REMARKS

Applicant has carefully reviewed the Official Action dated August 02, 2000 and this Amendment is intended to be fully responsive to the Action.

Fig. 1

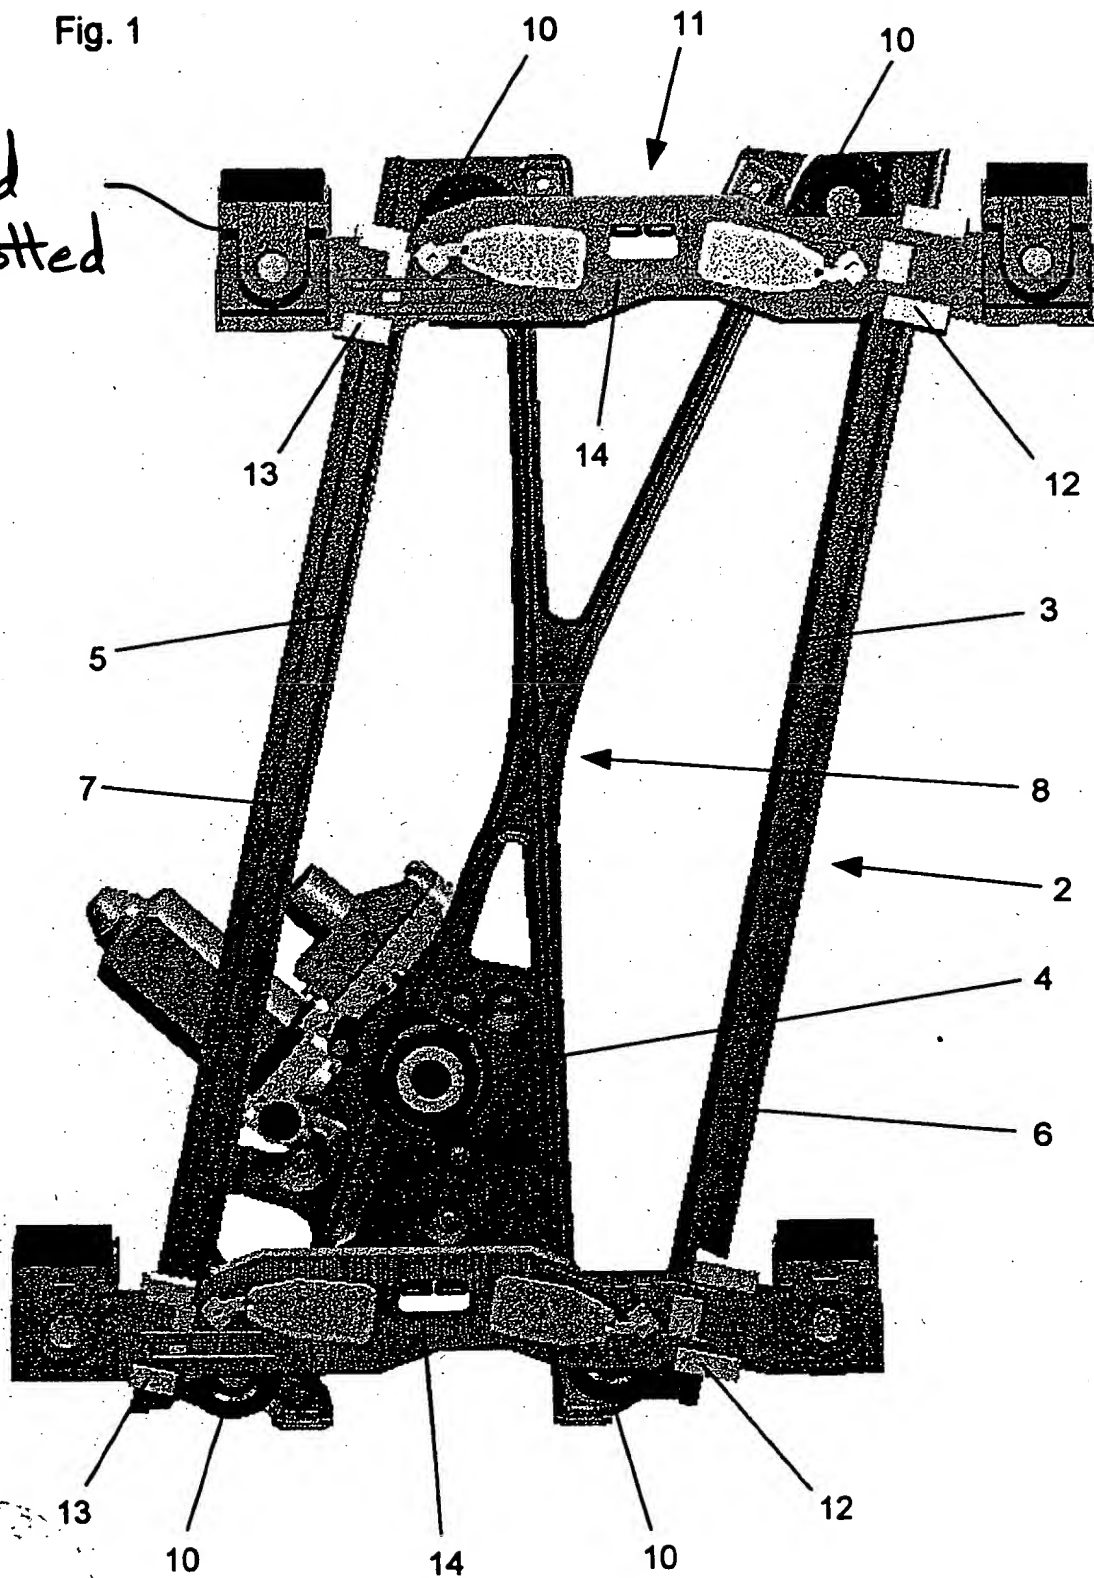
The drawings were objected to because the figures do not clear show the crossbar 14 (two crossbars 14 shown in Figure 1). It is noted that only one crossbar 14 is present in this invention. Original figure 1 merely shows the same crossbar 14 in two different positions. In addition, the Examiner objected to the use of the same reference numeral to denote different components. Lastly, the drawings were objected to for failing to illustrate the subject matter of claim 5.

corrected
+ be dotted
lines

Applicant has submitted a separate Letter to the Draftsperson requesting approval of several drawing correction intended to overcome these objections. Specifically, Figure 1 has been corrected (replaced) to show the crossbar 14 in dotted lines at the upper position. Figure 2 has been corrected to illustrate the limitations of original claim 5. In addition, Figures 2 and 3 have been amended to denote the reference numerals of Figure 2 with a single prime or dash (e.g., 10') and the reference numerals of Figure 3 with a double prime or dash (e.g., 10''). The corresponding reference numerals in the specification have been amended accordingly. No new matter has been entered.
